# DUKE POWER COMPANY

Re: Catawba Nuclear Station  
Docket Nos. 50-413 and 50-414

As a result of a meeting with the Reactor Systems Branch on June 28 and 29, 1982, Duke Power Company is transmitting herewith responses, revised responses, or partial responses to the following FSAR questions:

Figure Q440.128-1  
Rev. 6

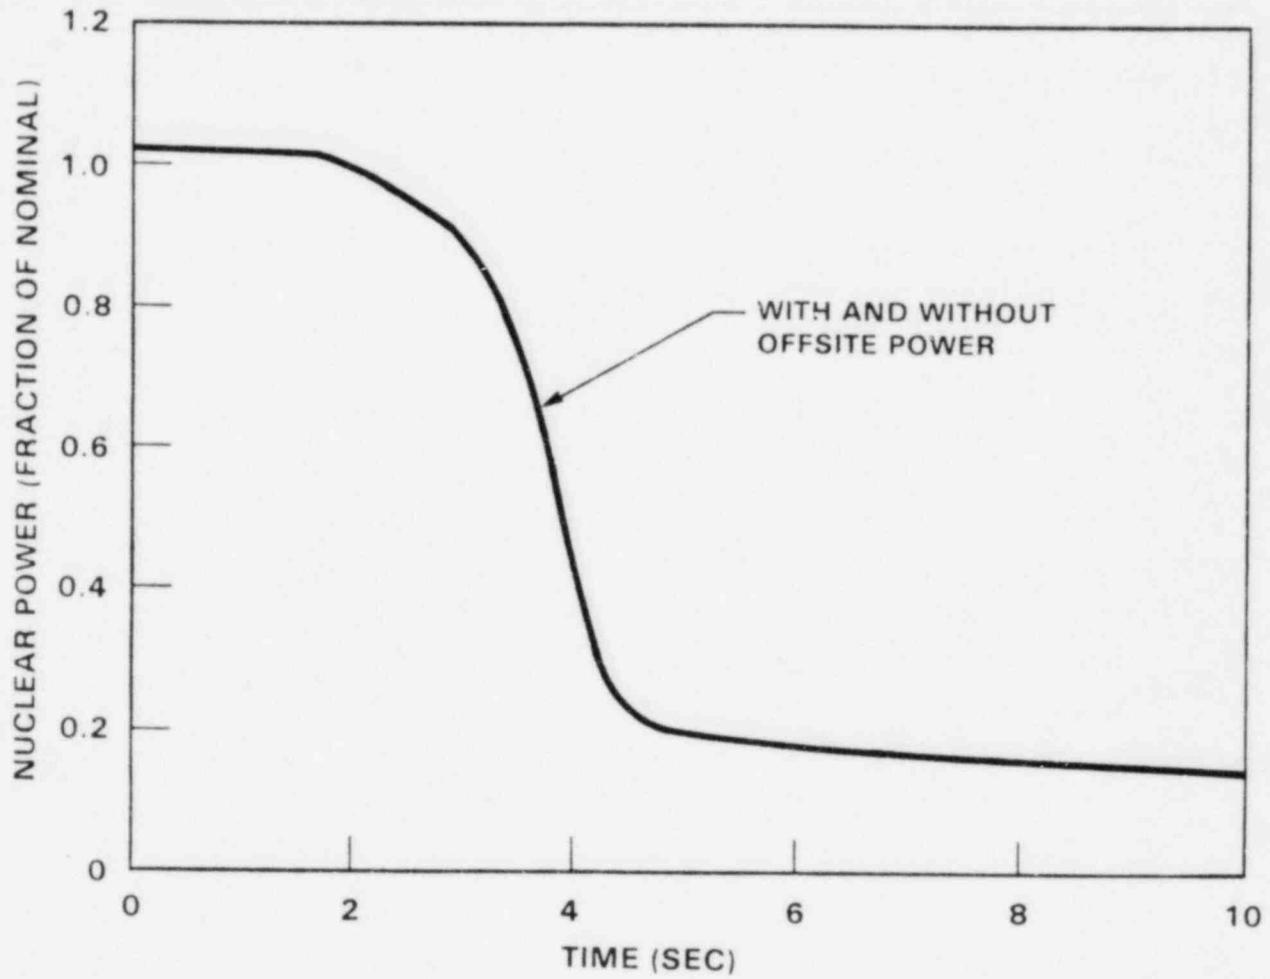
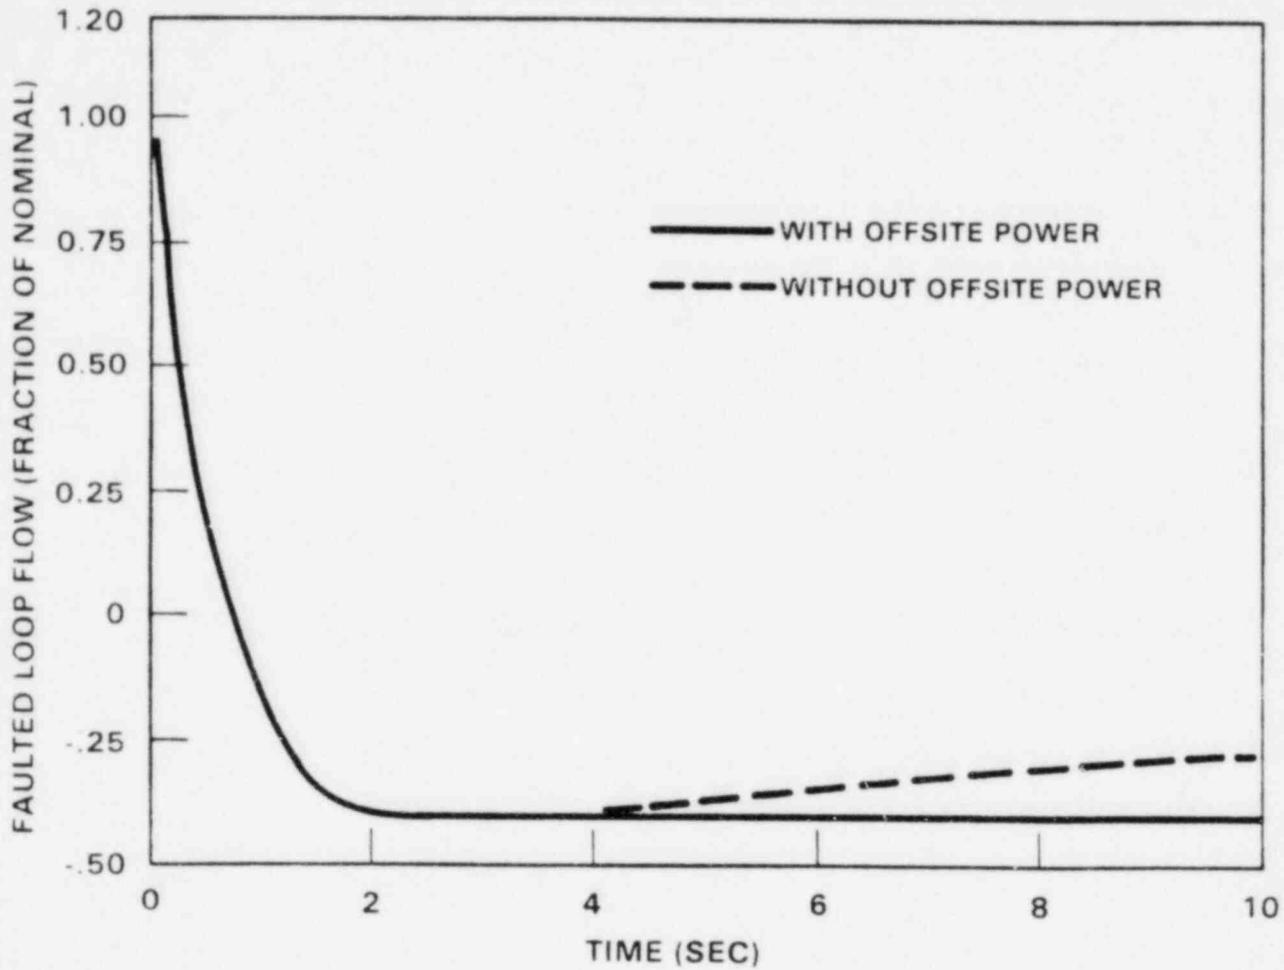
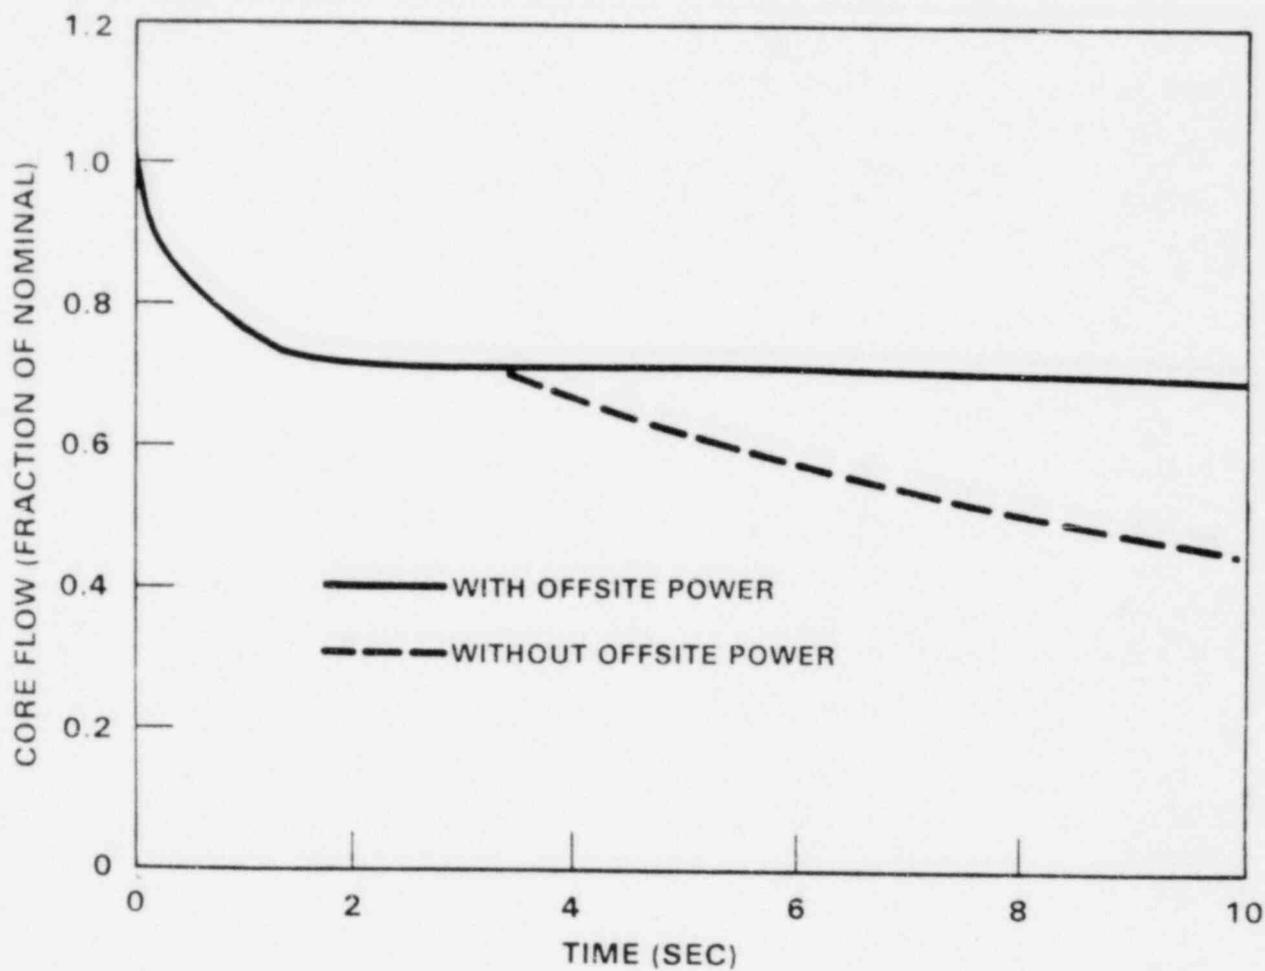
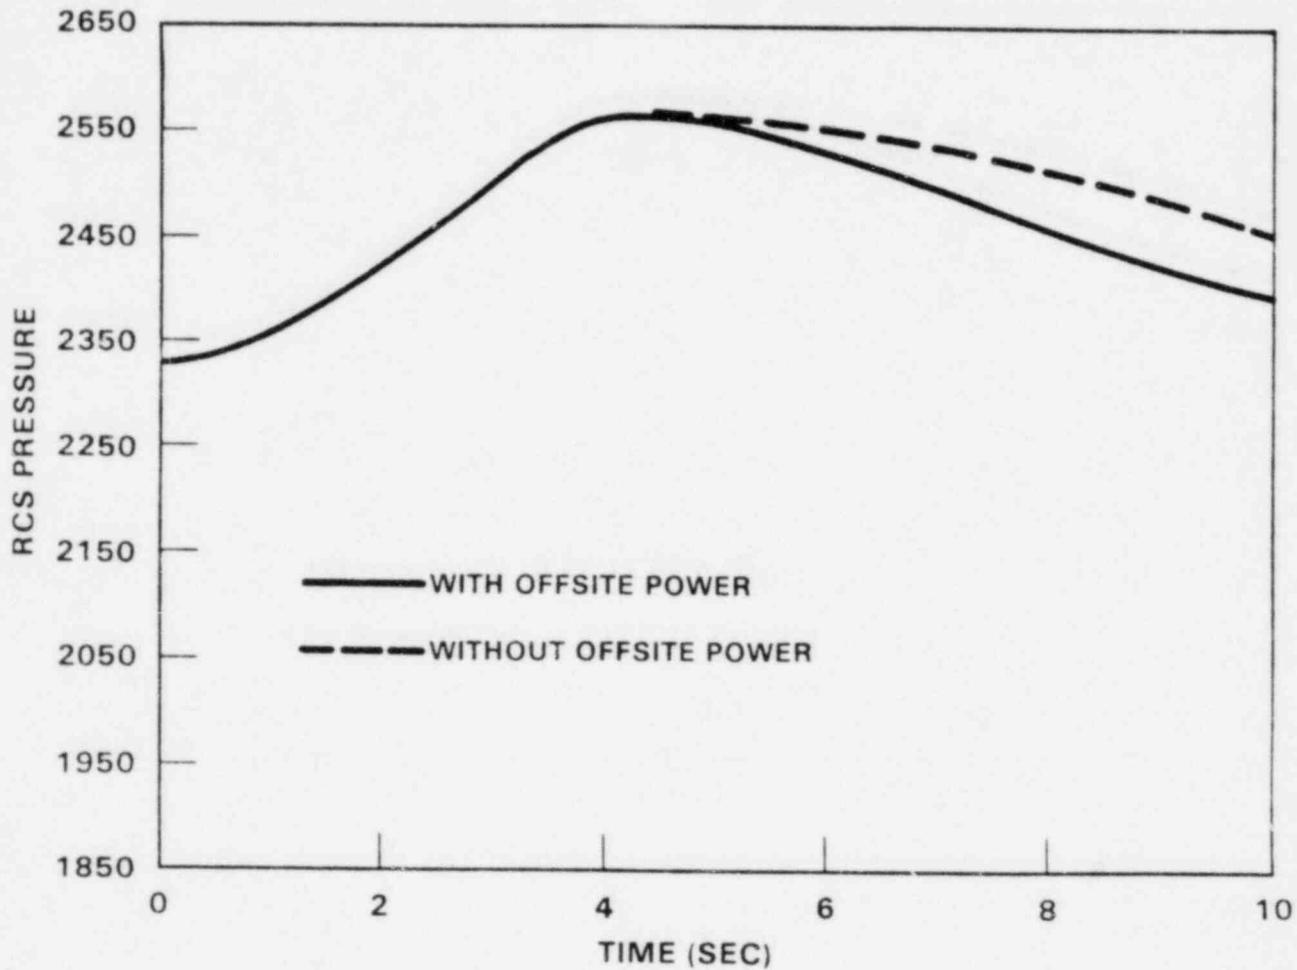
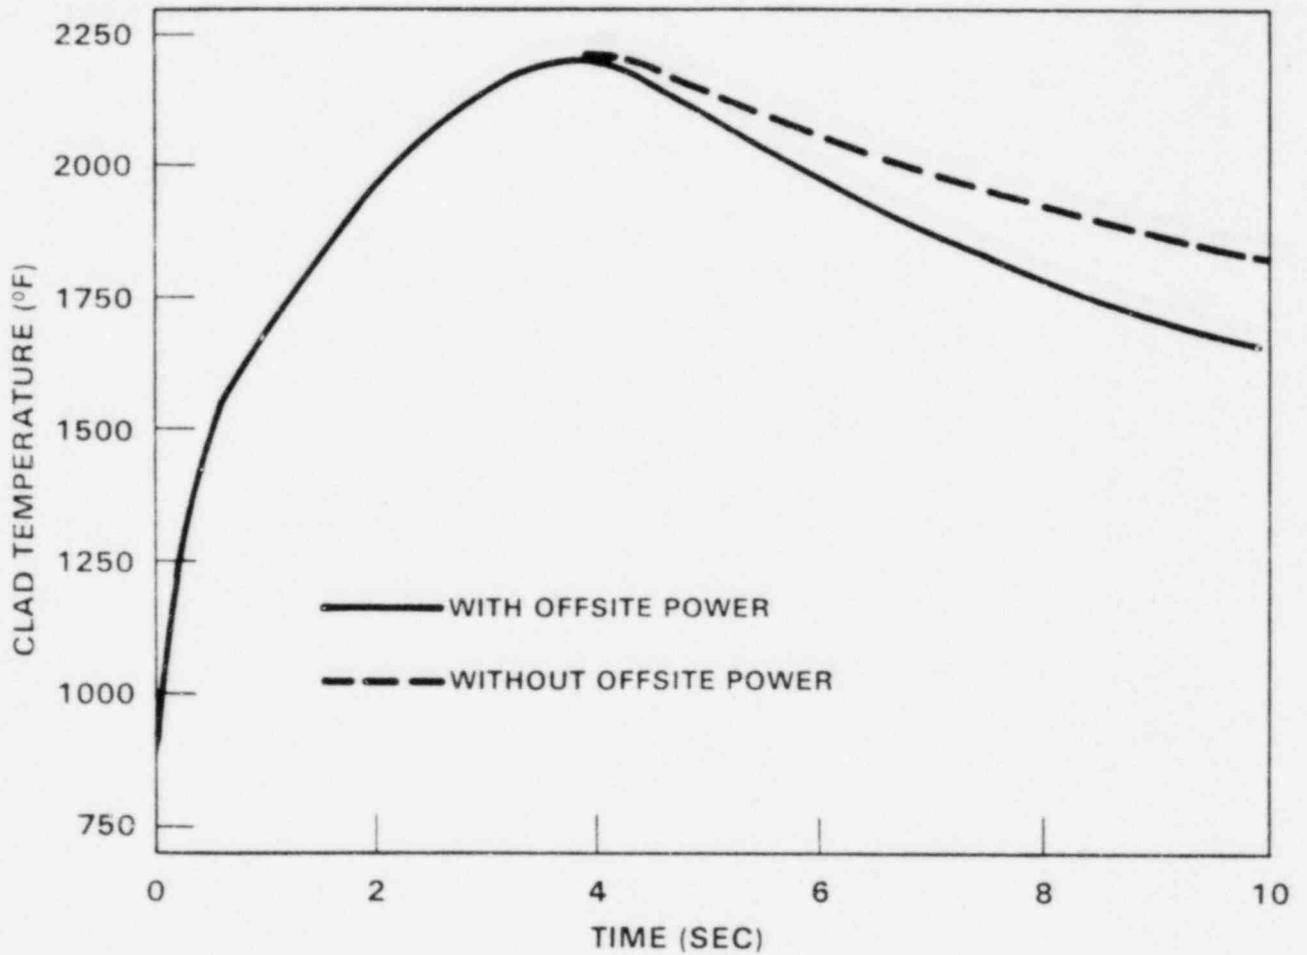
It is not apparent from your response to Questions 440.85 and 440.87 that you intend to analyze the locked rotor and shaft break transients consistent with the acceptance criteria in SRP 15.3.3 - 15.3.4 in NUREG-0800. We require that this event be analyzed assuming turbine trip and loss of offsite power to the undamaged pumps. The event should also be analyzed assuming the worst single failure of a safety grade system active component. Maximum primary system activity (in addition to activity from fuel failure resulting from the transient) and maximum steam generator tube leakage as allowed by the technical

Figures Q440.128-1 through -5 show a comparison between the locked rotor transient without offsite power and the locked rotor transient with offsite power from Section 15.3.3. As can be seen from the figures, losing offsite power results approximately in the same peak clad temperature and the same peak RCS pressure.

Figure Q440.T.7-1  
 Rev. 6

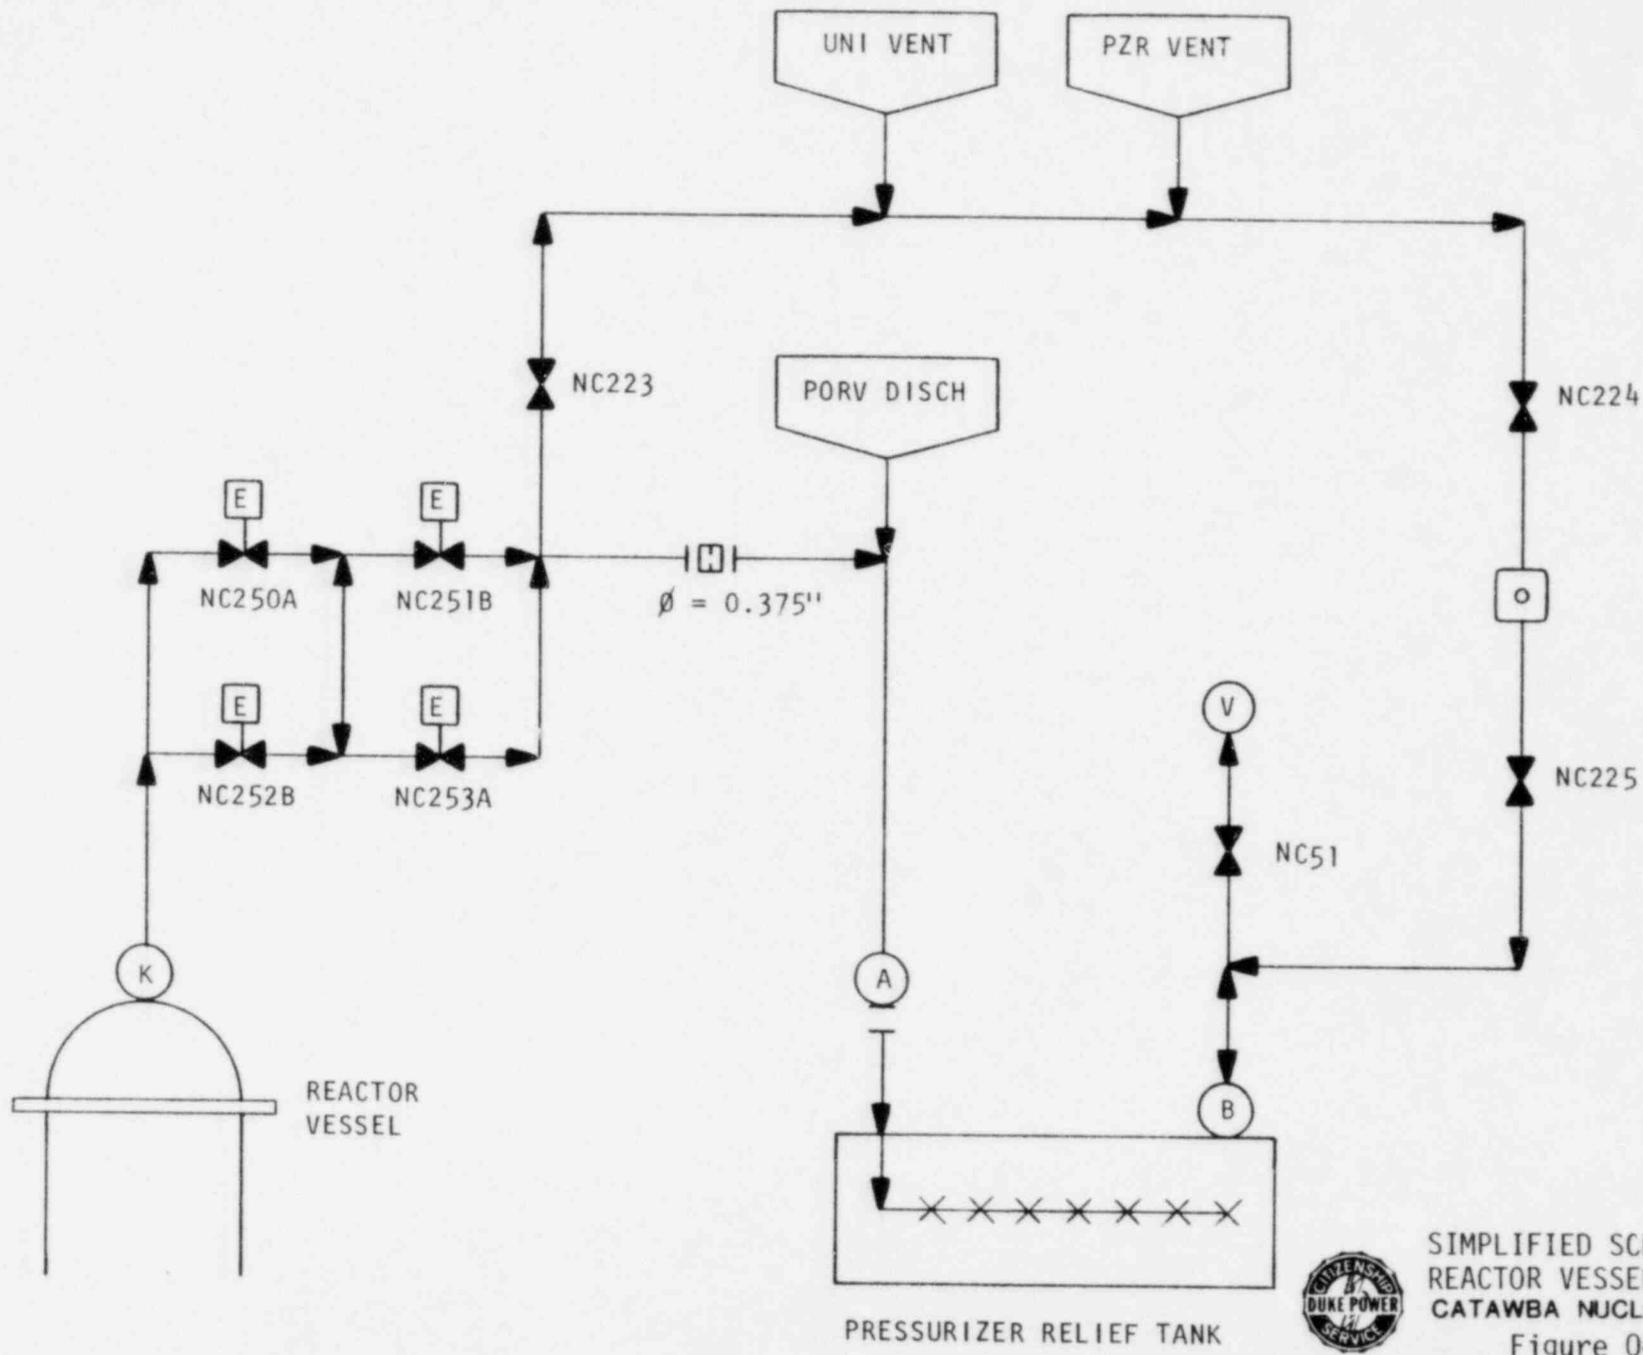
- (a) Table 1.9-1 Item II.B.1, RCS Vents, states that the system design appears on Figures 5.1-1 and 5.1-2. Provide a more legible schematic design of the vent system with identification of each valve by the valve number.
- (b) Provide information on the following items, which apply to the vent system up to and including the second normally closed valve:
  1. the design temperature and pressure of piping, valves and components.
  2. Verify that the piping, valves, components and supports are classified Seismic Category 1 and Safety Class 2 (or Safety Class 1 for those parts upstream of the flow restricting orifice).

- (a) See Figure Q440.T.7-1
- (b) 1. Design Pressure - 2500 psia  
Design Temperature - 650°F
2. Piping, valves, components and supports are classified Seismic Category I and Safety Class 1 up to and including the second normally closed valve; Safety Class 2 up to and including the flow-restricting orifice.
